ADDENDUM 2

Date: September 5, 2024

Re: NOTIFICATION OF ADDENDUM 2:
David. T. Cardenas Senior Center & Police Headquarters Project.

A4 ENTRY CANOPY FRONT ELEVATION
 Scale: 1/4" = 1'-0"

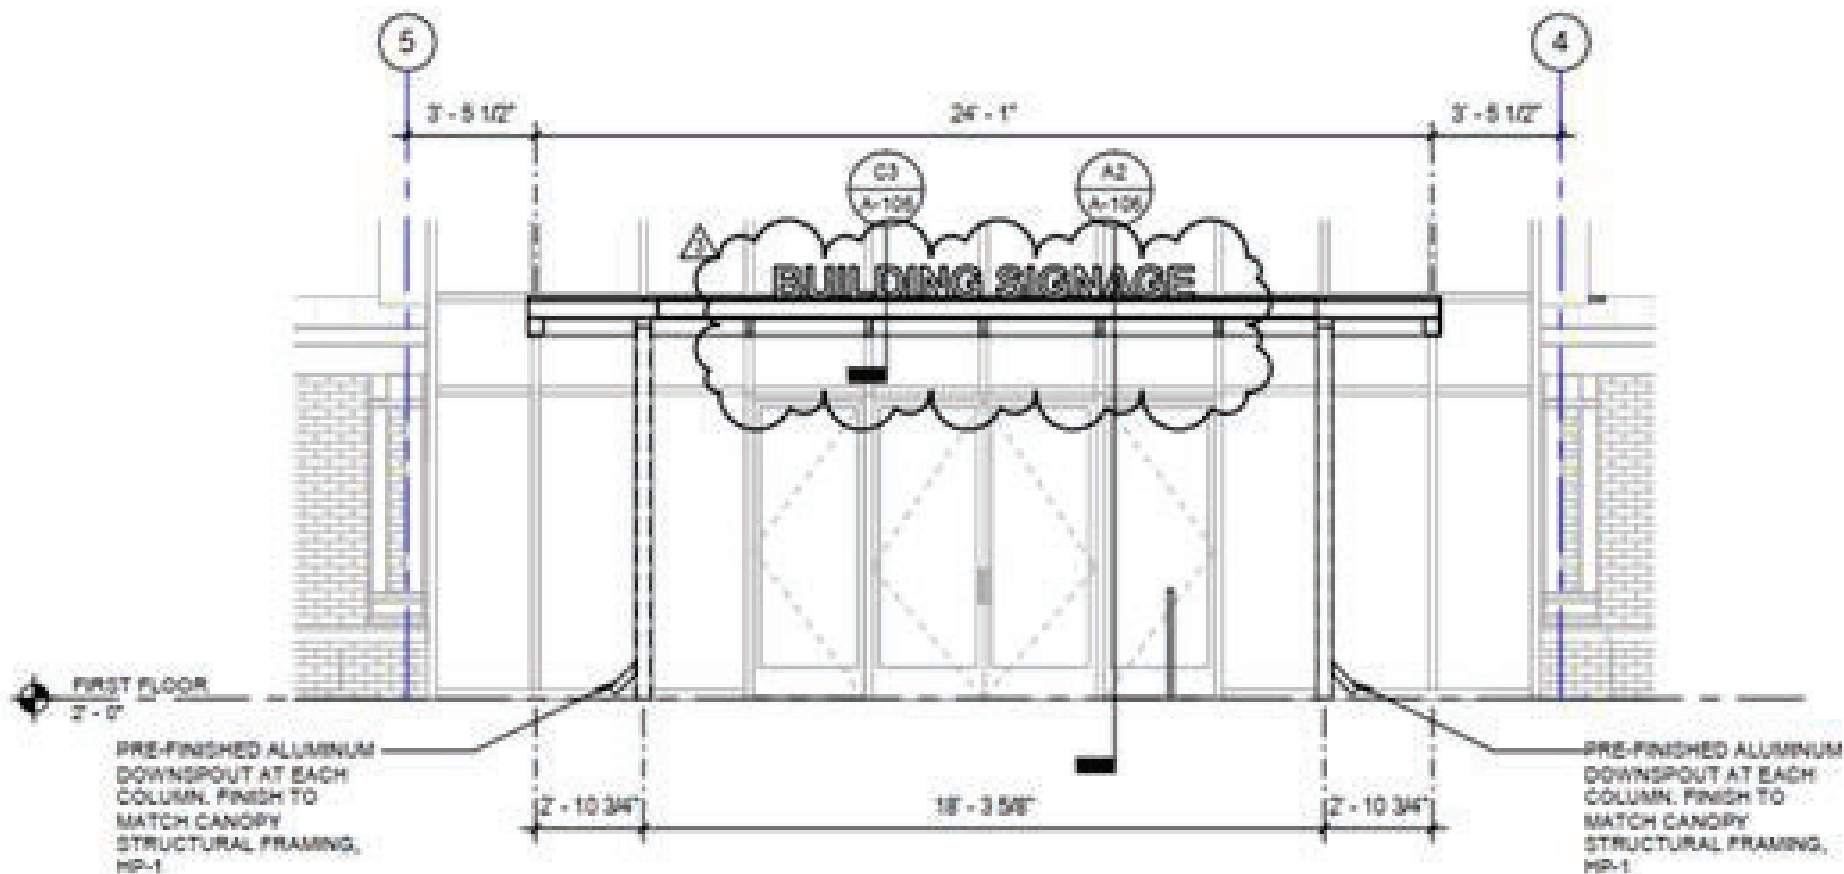
1. The specified manufacturer does not produce photopolymer signs. The specification document mentions "Photopolymer face sheet with raised graphics laminated to acrylic backing sheet to produce composite sheet," while plan sheet no G-410 states, "INTERIOR SIGNS SHALL BE MADE OF 1/4" VINYL PLATE, UON." Please advise on the appropriate material for interior signage.
2. Could you please clarify the scope for the monument sign in this project?
3. We noticed there are no details or markings for plaque signs, but the specifications mention a requirement for them. Could you please specify the scope for plaque signs?
4. Could you share the artwork for the exterior building sign? (Screenshot attached for reference.)

1. Revised list of manufacturer and detail on Sheet G-410 and will be include as part of Addendum #3.
2. Refer to Addenda #2 Signage Allowance scope of work.
3. Refer to Addenda #2 Signage Allowance scope of work.
4. Refer to Addenda #2 Signage Allowance scope of work.

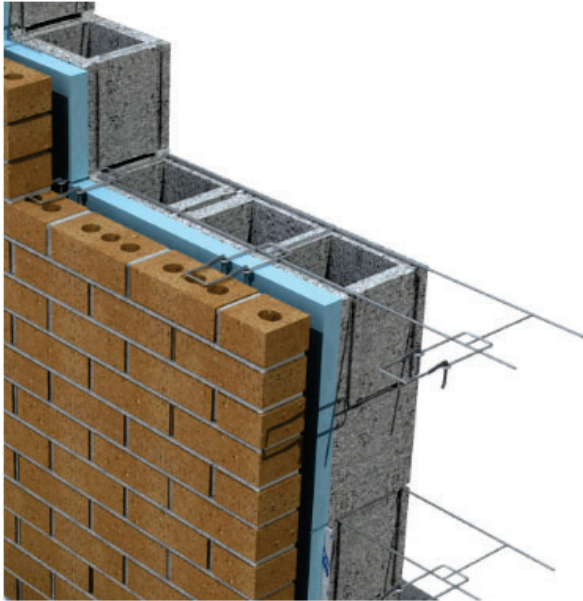
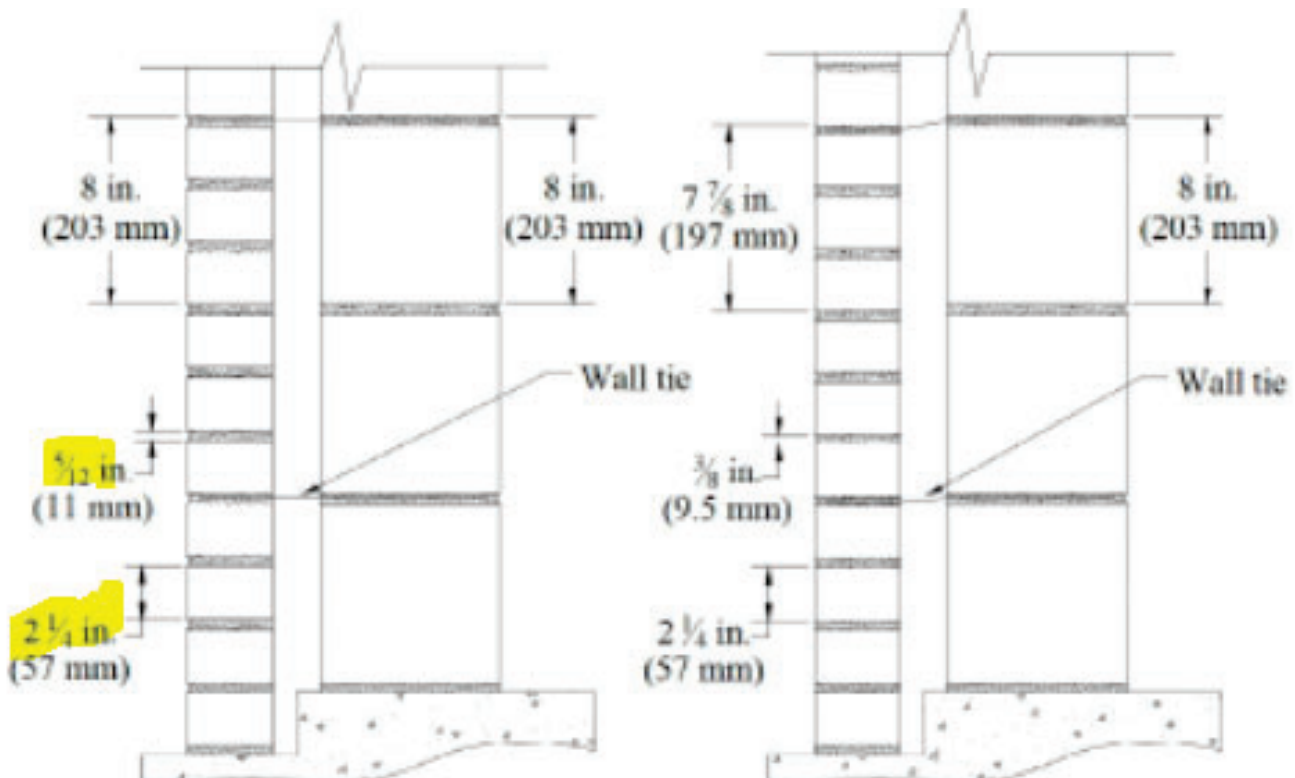
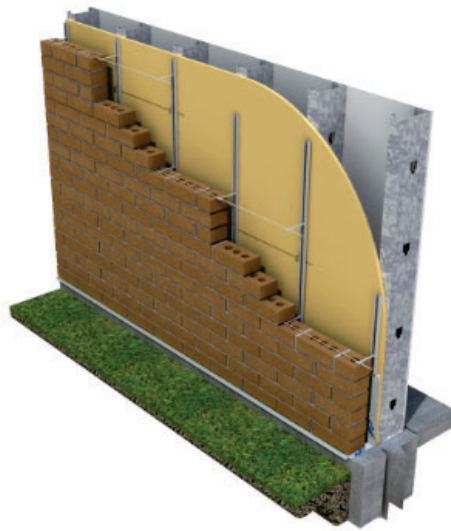
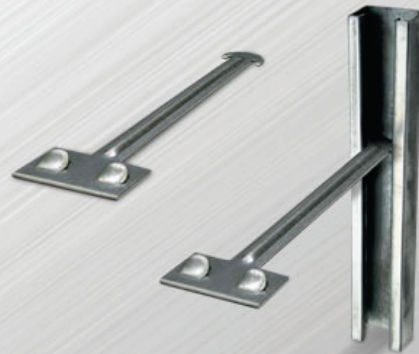
The plans and specifications refer to Ladder Lock Loop embed wire type anchoring system. This works only if the brick lay to 4". Modular brick lay to 2-3/4", every third course we will gain 1/4" per block. That equates to 1/2" gain every two CMU courses. Please advise if Channel Tee Seismic Notch Anchor System / Flemming Anchoring system is acceptable in lieu of Ladder Lock Loop system as it's more versatile and works with all sizes.

The Fleming Anchor and the H-B Channel-Tee Seismic-Notch Anchor appear to be for use with a metal stud back-up and not CMU. All brick has CMU back-up on this project. Modular brick is 3 courses per 8", so the modular brick aligns with the CMU joint. See chart on next page. Joints are not a true 3/8" joint. Modular brick (2 1/4" tall) has been used with eye and pintle type horizontal reinforcing for decades. See following pages for images of the Ladder Eye system and alignment, as well as a coursing chart, and images of the Channel Tee.

⑦ SECTION AT LIEUTENANT
1/4" = 1'-0"

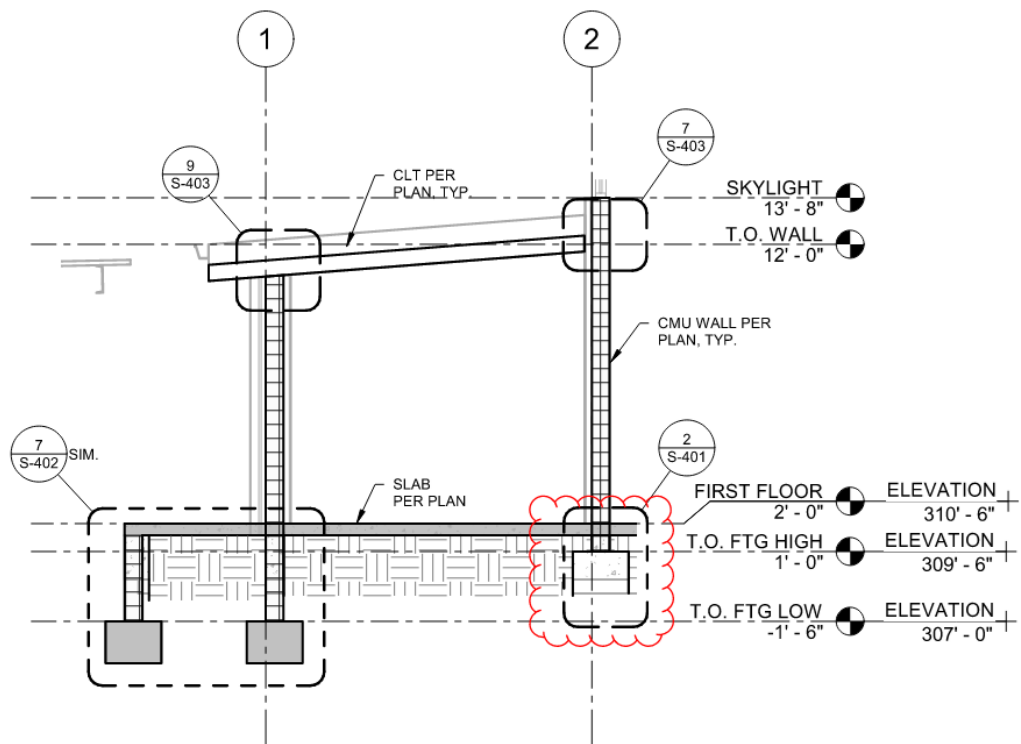
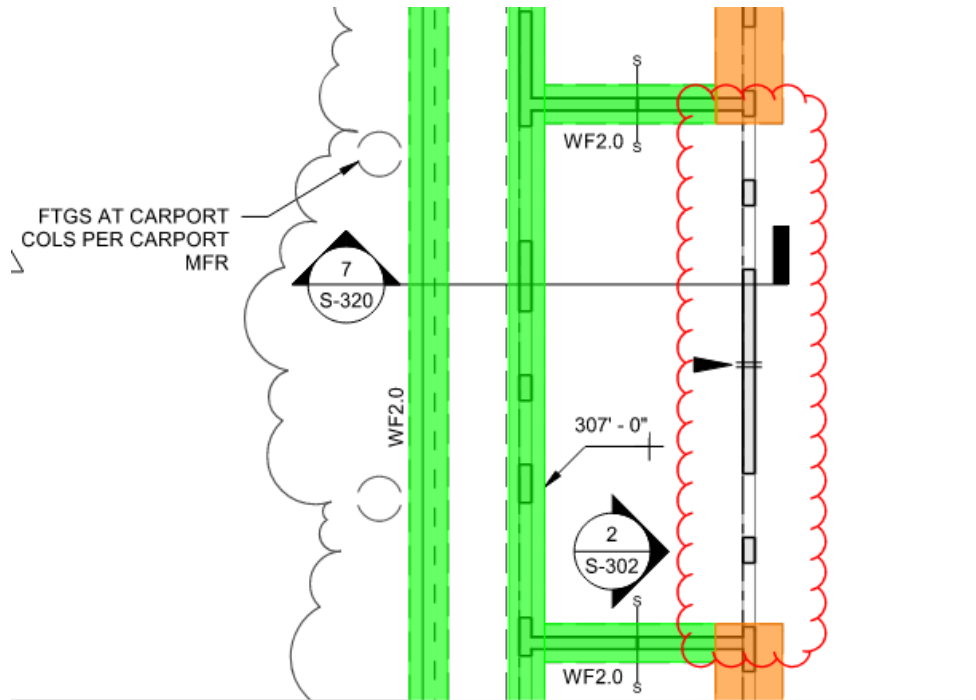
Plan sheet S-210 shows a gap in the WF3.5 at the location of the lieutenant's offices. Detail 7/S-320 shows a footing in this location.

Provide the footing per detail 7.

The gap between footings should not occur. Footing at that location should run continuous as a WF3.5.

① SECTION AT COVERED PORCH
1/4" = 1'-0"

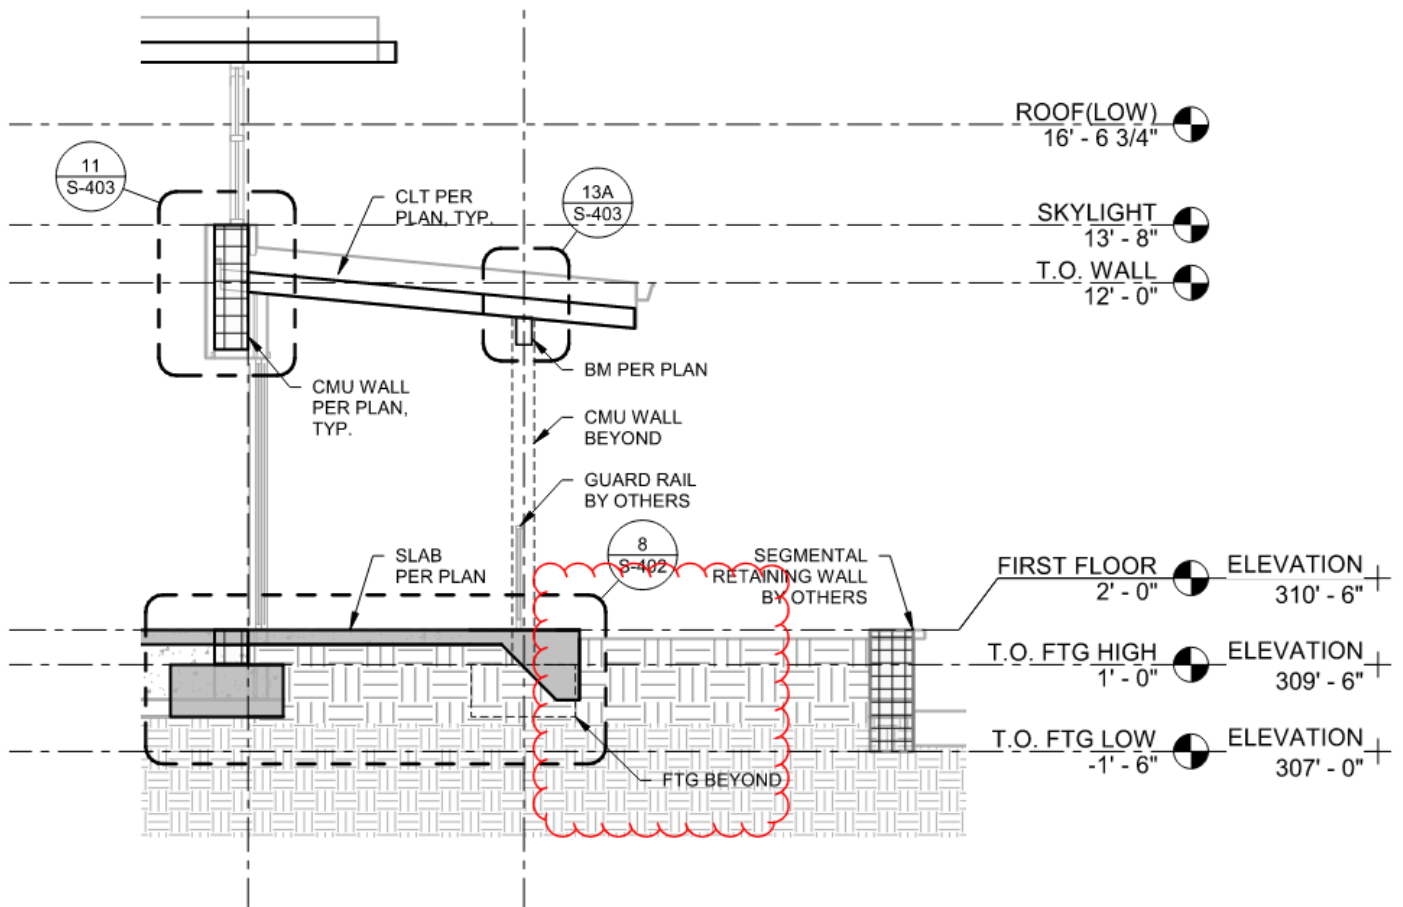
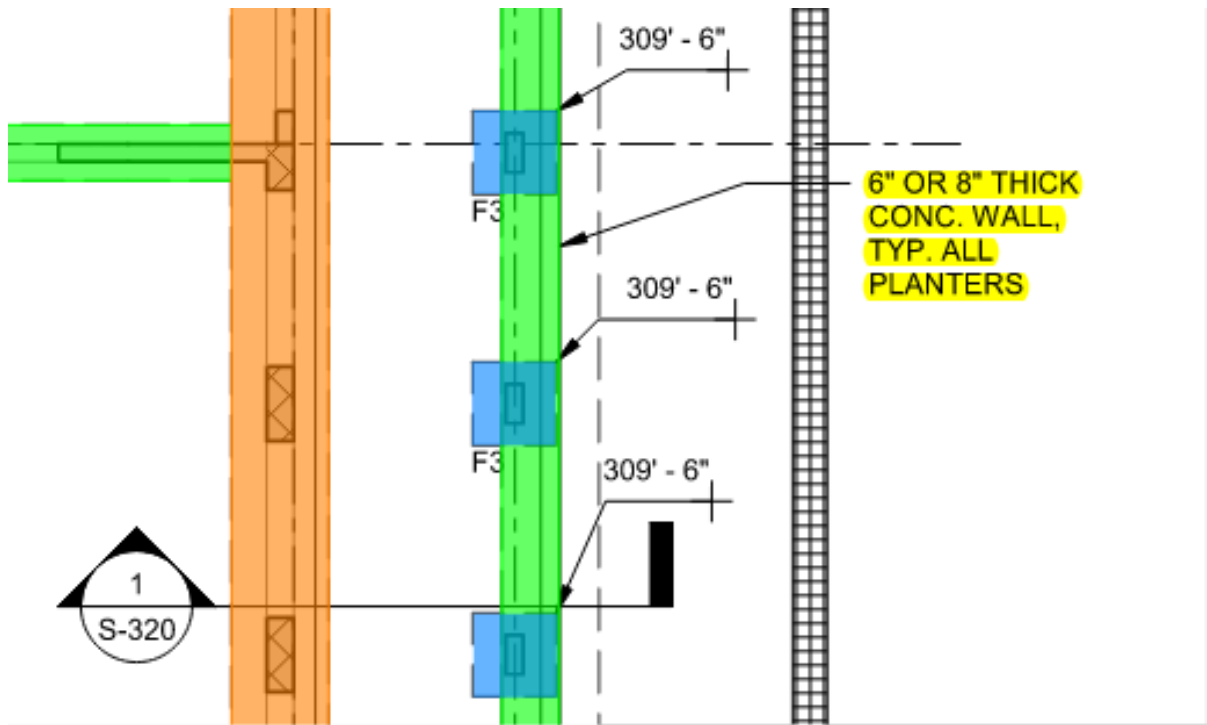
Plan sheet S-210 shows a "6" or 8" thick conc. wall typ. all planters. Detail 7/S-320 does not show the wall. Please advise if there should be a wall at that location per the plan or not per the detail. Please advise if the wall is to be 6" or 8" thick.

Provide a 6" wall per the plan

See attached SK-1 for clarification.

SK-1

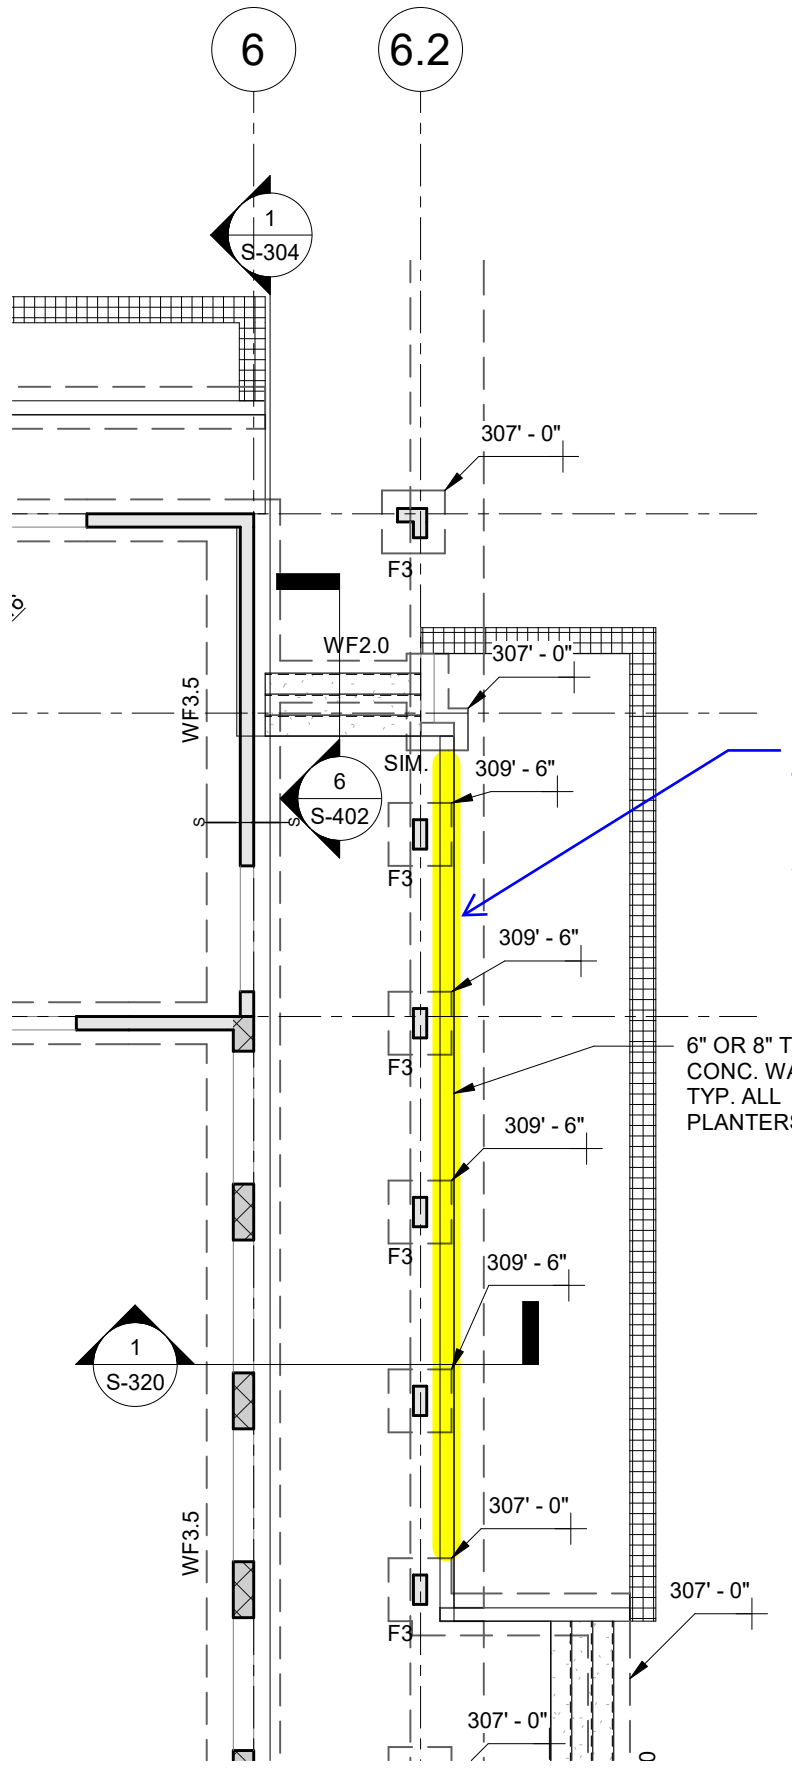
6" OR 8" THICK
CONC. WALL,
TYP. ALL
PLANTERS

NO PLANTER WALL
REQUIRED AT THIS
HIGHLIGHTED
PORTION. INSTEAD,
THICKENED EDGE
PER 8/S-402 IS
ACCEPTABLE - CG
